New Albany Architectural Review Board Agenda
Monday, September 12, 2022 7:00pm

Architectural Review Board Staff Report August 8, 2022

14 SOUTH HIGH STREET BUILDING ADDITION CERTIFICATE OF APPROPRIATENESS

**TENNIS AND PICKLEBALL COURT PARKING LOT
CERTIFICATE OF APPROPRIATENESS**

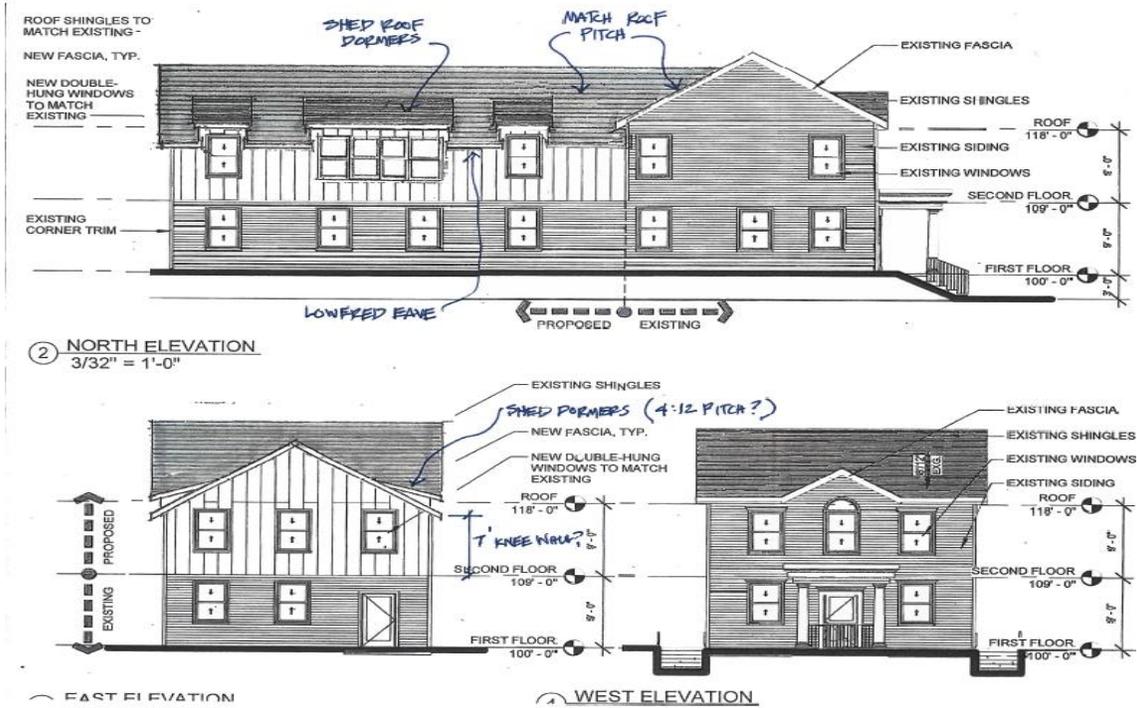
- The city architect has reviewed the application and comments that since the addition is a full two-story height structure, it doesn’t feel as if the renovation relates to the existing design as much as it should. The city architect recommends the following revisions:

- The visual break between the existing portion and new addition needs to happen at the eave.
- The roof pitch of the existing structure and new addition are to match.
- Shed roof dormers are to be added with a 4:12 pitch.
- The addition is to have a 7' tall knee wall between the existing one-story portion of the structure and the new roof for the addition.
- Staff recommends a condition of approval that all comments from the city architect are satisfied, subject to staff approval. The city architect created the following sketch to indicate what additional detailing he recommends:

- The city architect's rendering above shows how they recommend to visually separate the existing and new eave lines, in order to maintain a hierarchy of the original main building shape. This rendering, along with the city architect's comments, were provided to the applicant. The applicant responded by stating the property owner agrees to the revisions proposed by the city architect and they intend to provide updated renderings at the board meeting.

1. That the applicant must revise the design and drawings per the city architect's comments and the rendering provided, subject to staff approval.
2. The existing horizontal vinyl siding be replaced with horizontal Hardie board material.
